DSP-13025

STAFF REPORT

SUBJECT: Detailed Site Plan DSP-13025
University of Maryland Student Housing at Knox Road

ARCHITECTURAL ELEVATIONS (BUILDING A)

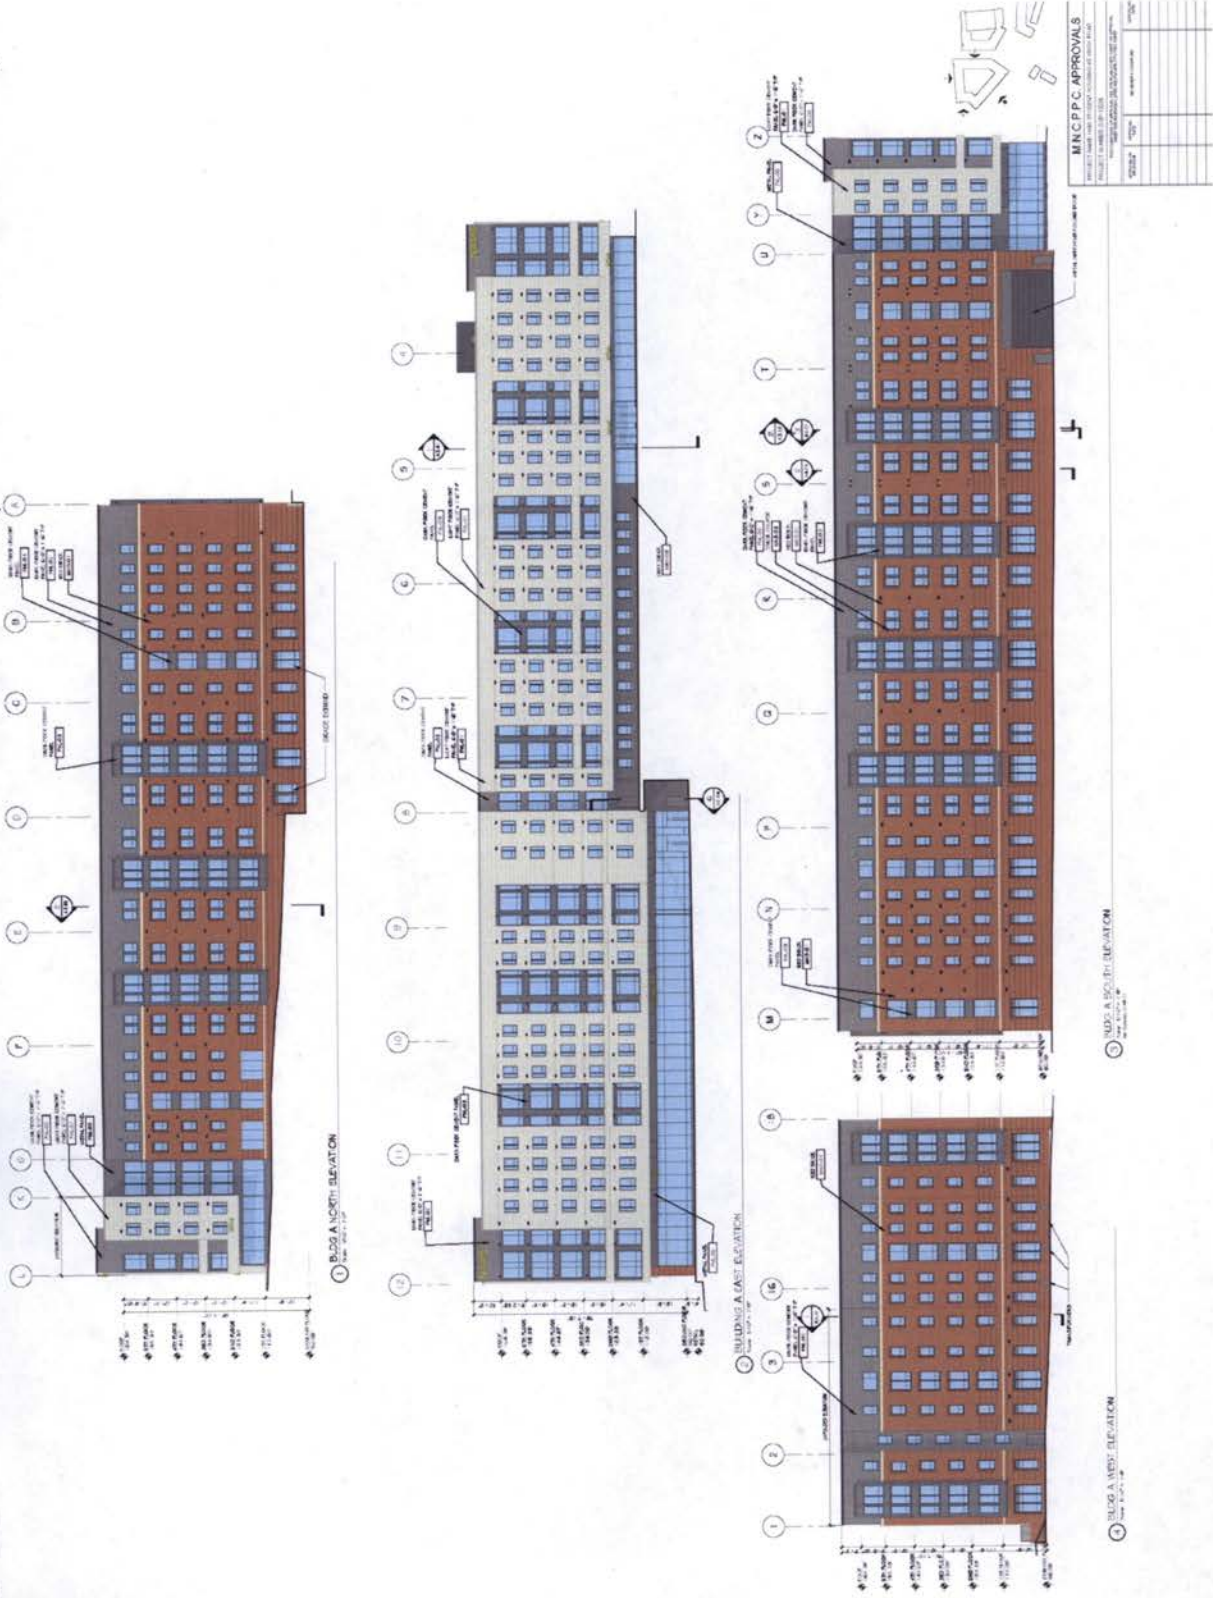
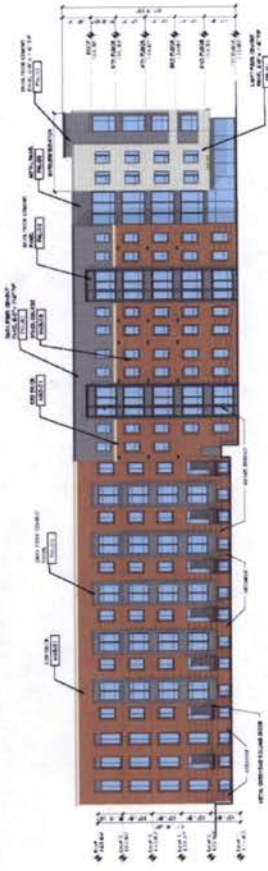
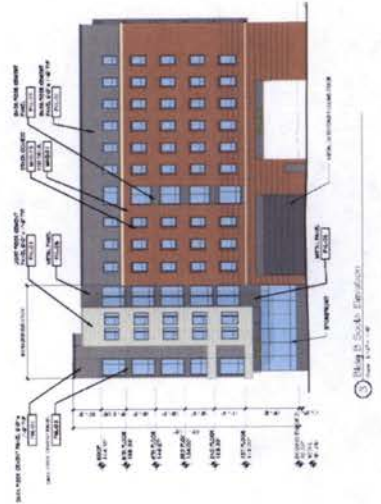
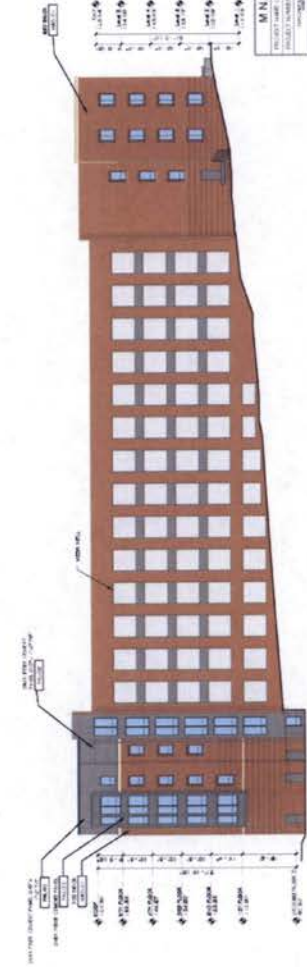
Architecture— Buildings A and B mirror each other. Due to the change in grade across the site the buildings are five stories fronting Knox Road, and six stories along Hartwick Road and Guilford Drive. The outward facing elevations are generally clad in red brick. Outward projecting vertical bays with a dark grey panel finish are proposed to extend from the second to the sixth story, and serve as a design element to break up the buildings' mass. The tops of the buildings are further defined by a dark fiber cement panel. Along the base of the building, horizontal bands of brick rustication are proposed to add visual interest. Along both sides of the mews the building material shifts to provide a more modern design gesture with the use of a light colored limestone-like panel. The vertical bay elements remain, except instead of projecting from the building façade they are recessed. The limestone panel is shown to extend up to the sixth story and along the entrances into the mews, as if to fold around the corner. Storefront glass and walls of dark grey masonry are proposed at the ground level of these elevations facing the mews. The interior courtyard elevations have a similar design aesthetic as the mews. The color and material palette is limited to light fiber cement siding, dark panel, and a dark brick base. Staff encourages the applicant to continue to refine these elevations through the use of additional attractive architectural detailing.

Staff believes that additional attention to the architectural façade design of the proposed multifamily buildings, courtyards, and townhouse-style units would greatly benefit the overall project and contribute to its success. Additional façade plane projections, such as additional vertical bays, the introduction of additional accent materials, cornices, and other architectural treatments should be provided to make these façades more interesting, while still allowing for the modern architectural character desired by the applicant. Staff encourages the applicant to refine the proposal to address some of the above-described recommendations prior to certificate approval of the plans.

EXHIBIT 1

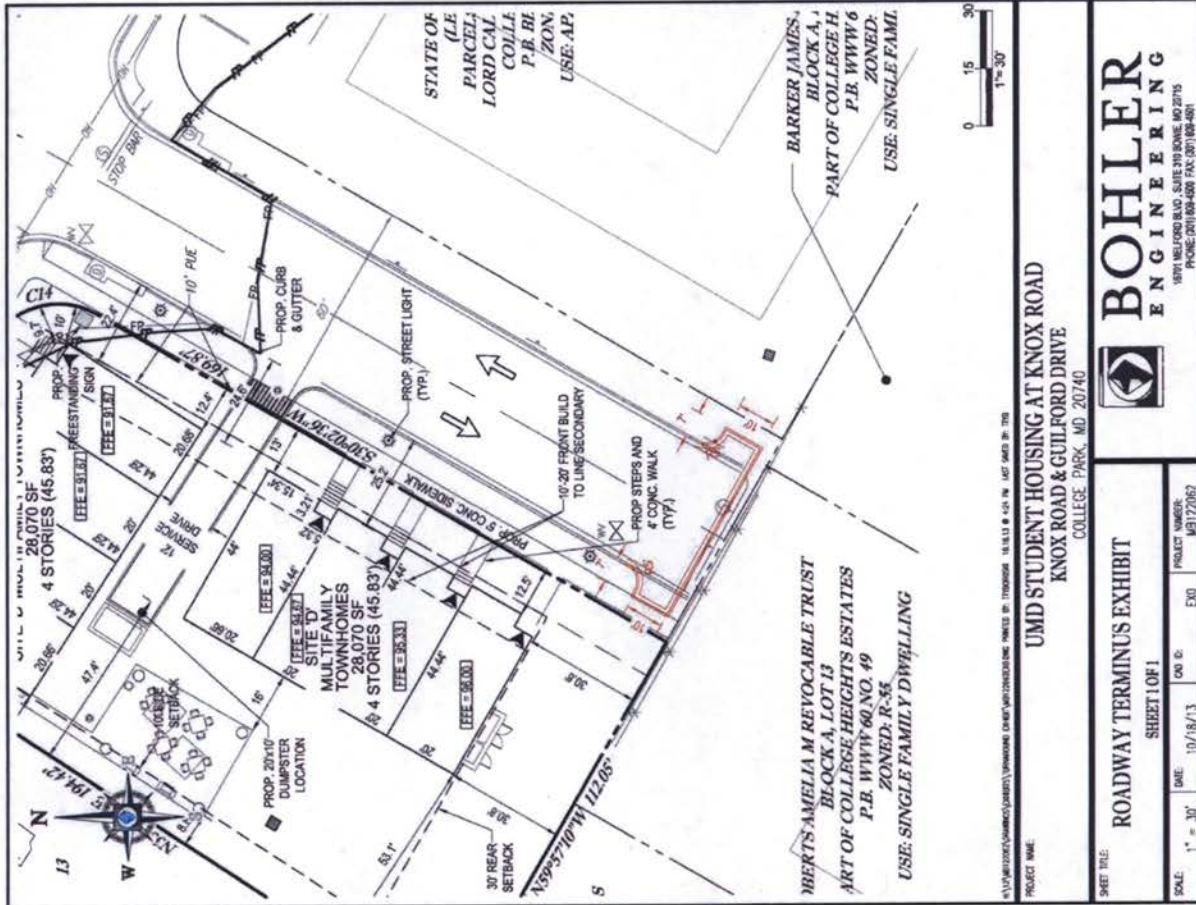
- “b. Redesign the mews/stairs to accommodate pushing a bike.
 - “c. Show street light fixtures spaced not more than 30 feet on center.
 - “d. Provide a hammerhead turnaround at the terminus of Roszburg Drive as shown on Exhibit 1.
